Access Compliance Report

Public Rights-of-Way

(Curb Ramps)

Intersection ID: 2743	Main Street: BELL'S_MILL_DR	Cross Street: HIGHLAND_CREEK_PY	Location: SE
ADA ID: F4F73E1C47E2	Ramp Type: Perp	Initial Pass/Fail: Fail	Overall Compliance: No
			Severity Score: 33.75

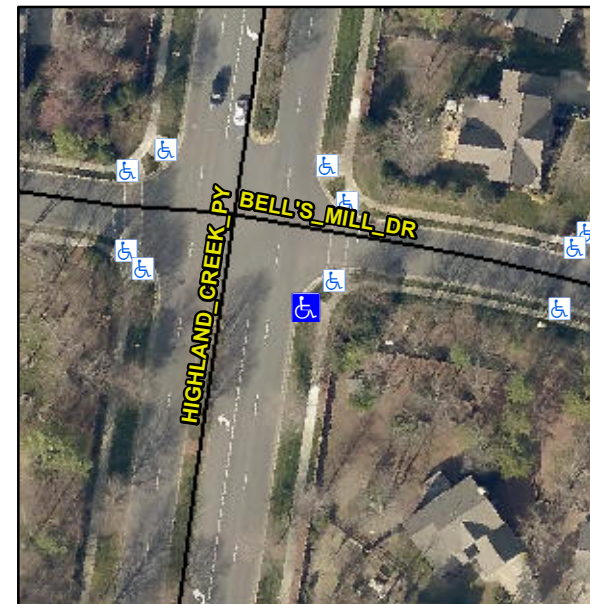
R304.5.1, R304.5.3

Compliance	Description	Data	Compliance	Description	Data
N/A	Ramp Length (in)	144.0	Yes	Ramp Slope (%)	8.2
No	Ramp Width (in)	42.0	No	Ramp XSlope (%)	7.0
N/A	Flare Type LT	N/A	N/A	Flare Type RT	N/A
N/A	Flare Slope LT (%)	N/A	N/A	Flare Slope RT (%)	N/A
N/A	Flare Traversable LT?	N/A	N/A	Flare Traversable RT?	N/A
N/A	Landing Length (in)	N/A	N/A	DWS Provided?	N/A
N/A	Landing Width (in)	N/A	N/A	DWS Contrast?	N/A
N/A	Landing Slope (%)	N/A	N/A	DWS Length (in)	N/A
N/A	Landing X Slope (%)	N/A	N/A	DWS Full Width?	N/A
N/A	Landing Curb? (Y/N)	N/A	N/A	DWS Offset (in)	N/A
N/A	Shared Landing?	N/A			
N/A	Gutter Ponding?	N/A	N/A	Gutter Slope (%)	N/A
N/A	Gutter Lip Ht (in)	N/A	N/A	Gutter X Slope (%)	N/A
N/A	Painted X Walk1?	No	N/A	Painted X Walk2?	N/A
	X Walk 1 Direction	To NW		X Walk 2 Direction	N/A
N/A	X Walk 1 Width (in)	N/A	N/A	X Walk 2 Width (in)	N/A
	X Walk 1 Slope (%)	2.9		X Walk 2 Slope (%)	N/A
	X Walk 1 X Slope (%)	5.1		X Walk 2 X Slope (%)	N/A

Remove & Replace Entire Ramp.
